গণপ্রজাতন্ত্রী বাংলাদেশ সরকার  
শ্রম ও কর্মসংস্থান মন্ত্রণালয়  
কলকারখানা ও প্রতিষ্ঠান পরিদর্শন অধিদপ্তর

ক্যাপ পর্যবেক্ষণের তথ্য

কারখানার নাম	শোনন সোয়েটারস লিঃ
ঠিকানা	Plot-A-118. S-36, BSCIC, Konabari, Gazipur
কারখানার কোড	GZP309
কালার কোড	
মূল্যায়নের ধরণ: <a href="#">কাঠামোগত মূল্যায়ন</a>	পর্যবেক্ষণের তারিখ: ১২-০৪-২০২৩
১. পর্যবেক্ষণ

### সংযুক্তি-সমূহ ( ৮ )

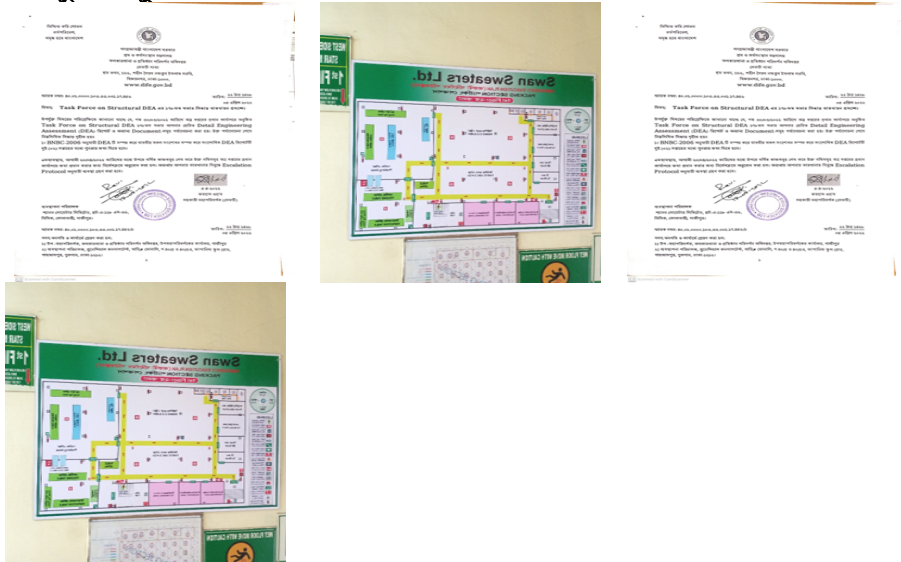
কার্যক্রম	Verify in-situ concrete stresses either by 100mm dia. cores or existing cylinder strength data for identified B6 columns.
সুপারিশের তথ্যসূত্র	
কারখানার কার্যক্রম	
অগ্রাধিকার	প্রযোজ্য নয়
চূড়ান্ত সময়সীমা	-
সংশোধিত সময়সীমা	০১-০১-১৯৭০
অগ্রগতির অবস্থা	সংশোধিত
মন্তব্য	09-April-2019: Core test results have been found on site with different name of the factory. No evidence of core cutting have been observed on site. 07-Nov-2019: Core test results have been found on site with different name of the factory. No evidence of core cutting has been observed on site. 04-Mar-2020: Core test report was found but factory name mentioned in core test report is not matched. Also, evidence of core cutting was not possible to verify due to plastering work. 19.10.2020: DEA report was submitted to DIFE for approval which covers the core test report. But the core test report states different factory name and no core cutting evidence was seen during inspection. 06-01-2021: Core test results have been found on site with different name of the factory. No evidence of core cutting have been observed on site. 10.08.2021: Core test results have been found on site with different name of the factory. No evidence of core cutting have been observed on site. 17.08.2022: Core test results have been found on site with different name of the factory. factory management says that, when the DEA work start & Core has been taken of the building then the factory name is Mega Fashion Wear Ltd. DEA Completion, return for correction & resubmission continue after a long time. in the mean time factory name is change by Shanon Sweater Ltd. Again after a same day factory change name by Swan Sweater Ltd. Also we verify core layout plan. core layout plan are matched with provide core layout plan. 12.04.2023: Completed.
